PROJECT NUMBER
 468-84551

PROJECT NAME
 SANITARY SEWER IMPROVEMENTS
 LINE 3 & 4
 WICHITA, KANSAS

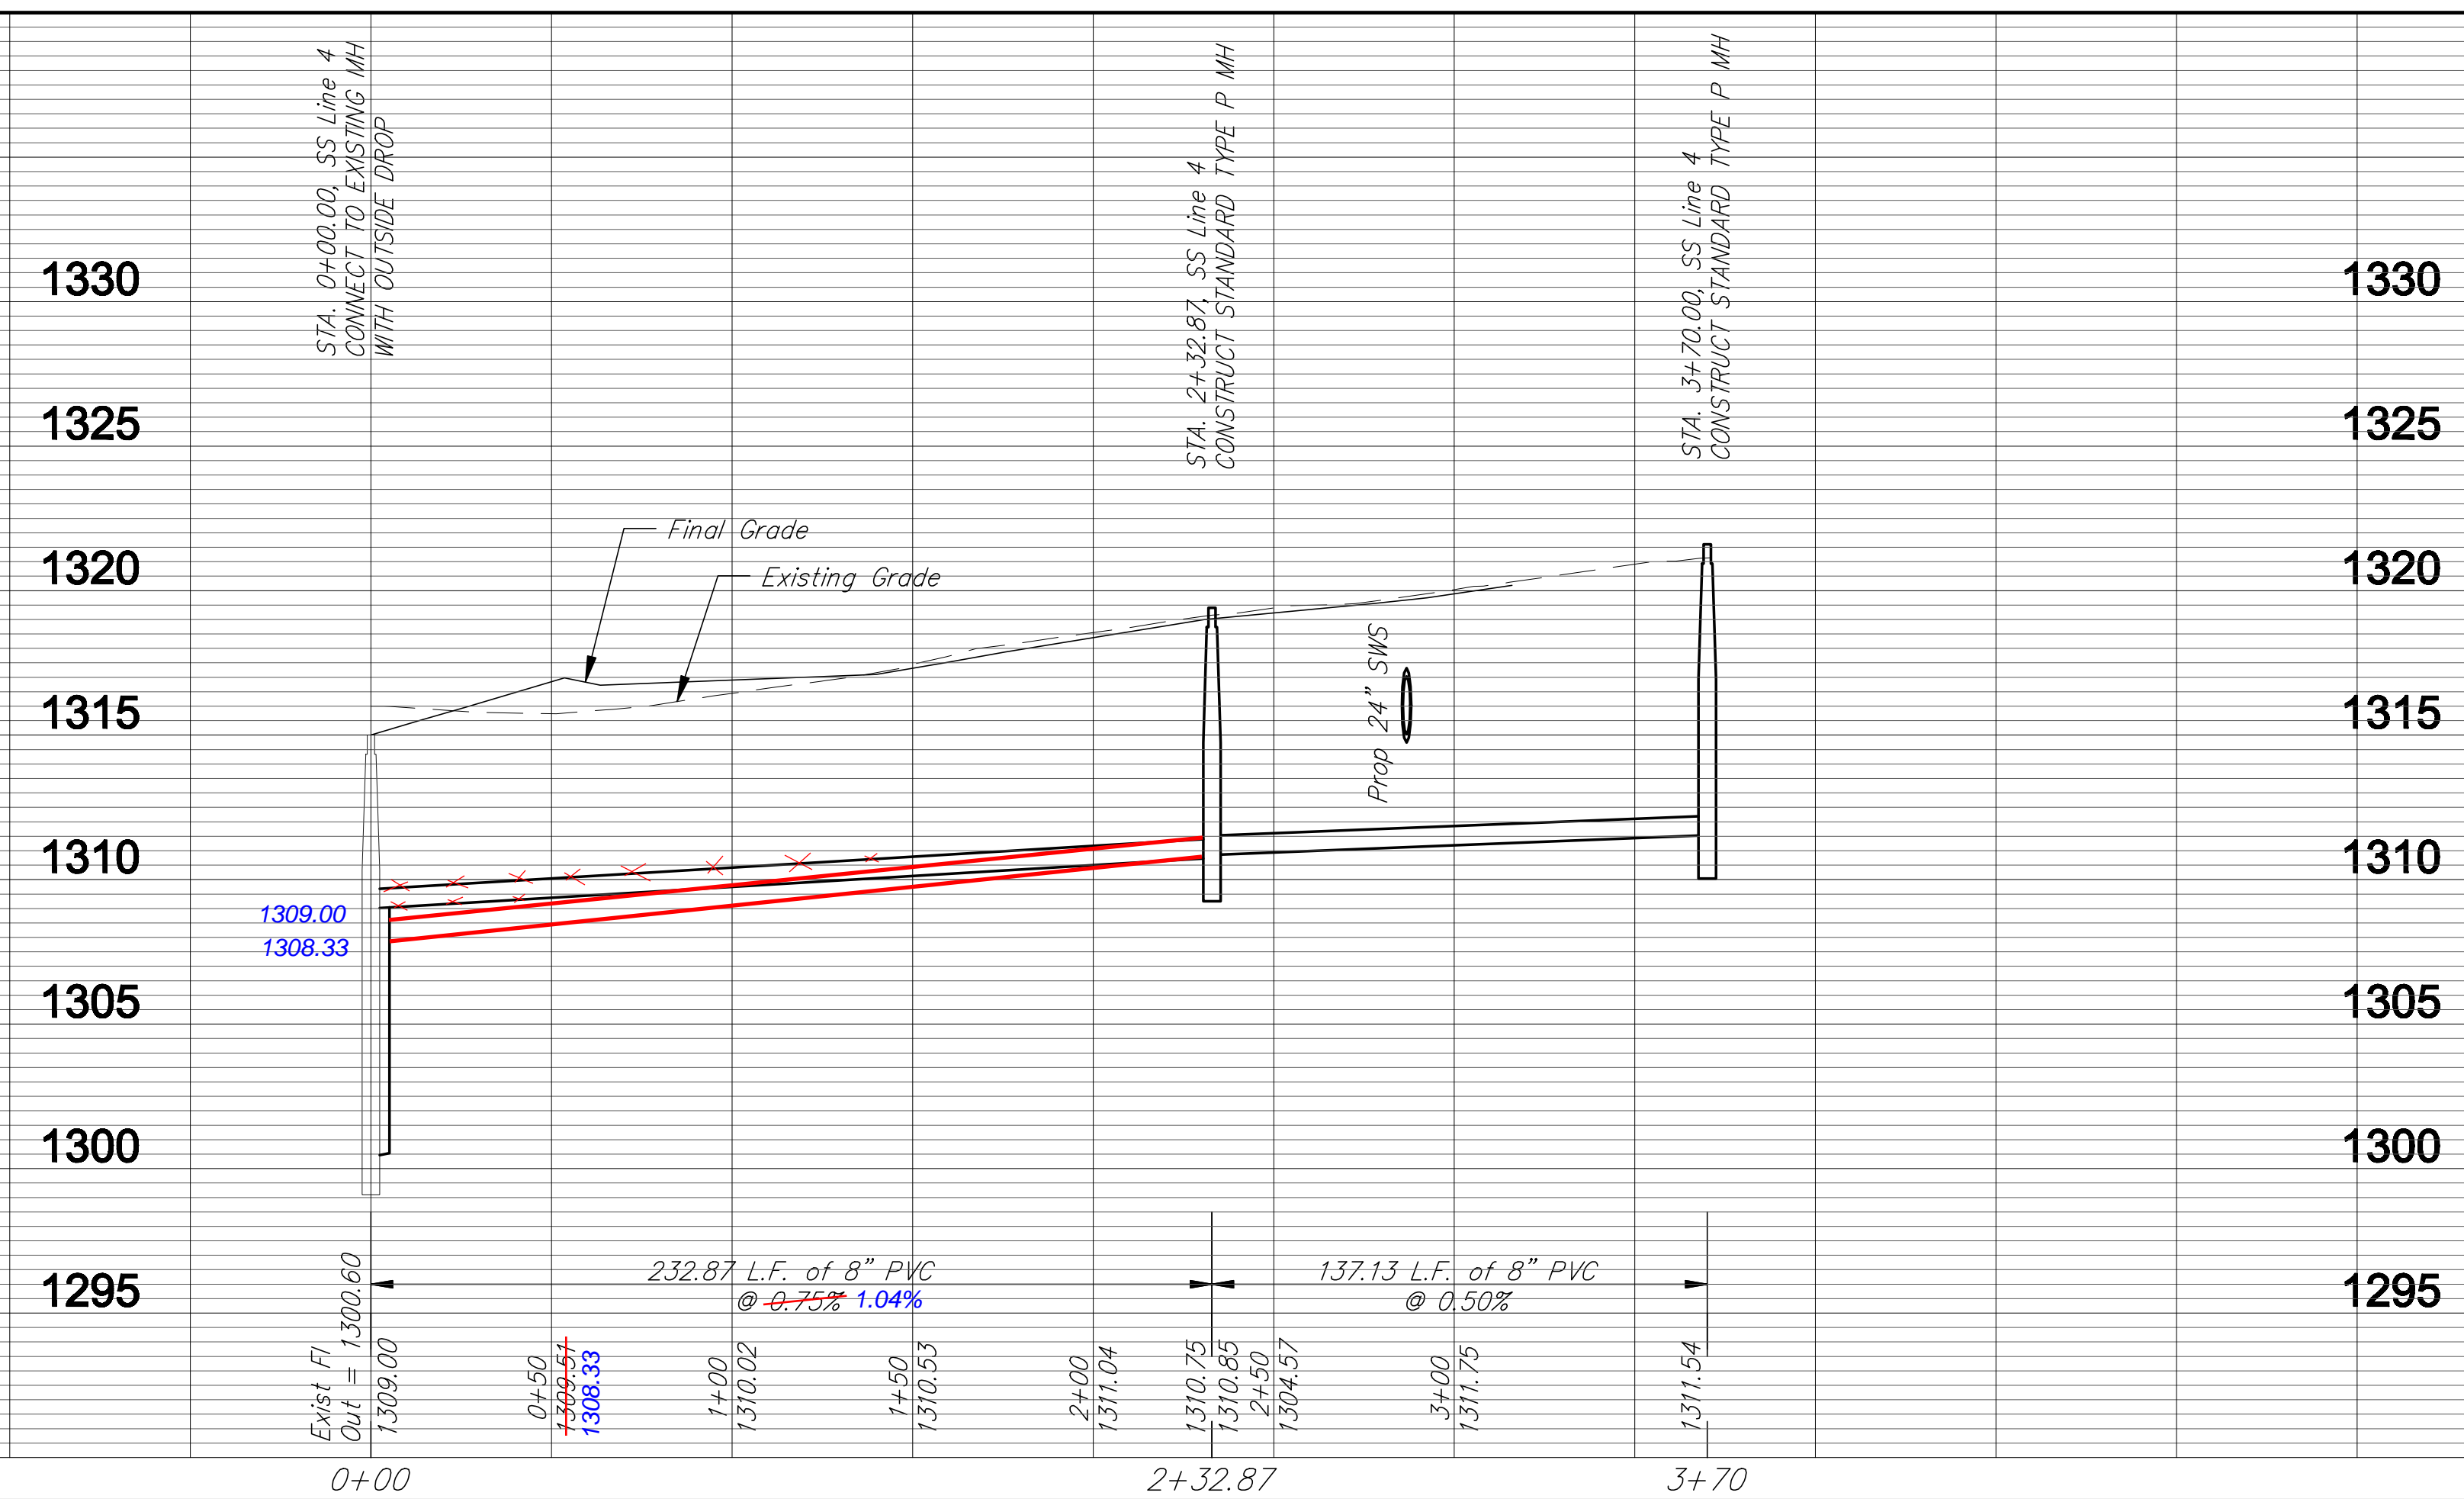
Note: Core driller made a mistake in drilling - took mark of mh as top of pipe instead of bottom of pipe resulting in pipe installed 8" lower than planned.
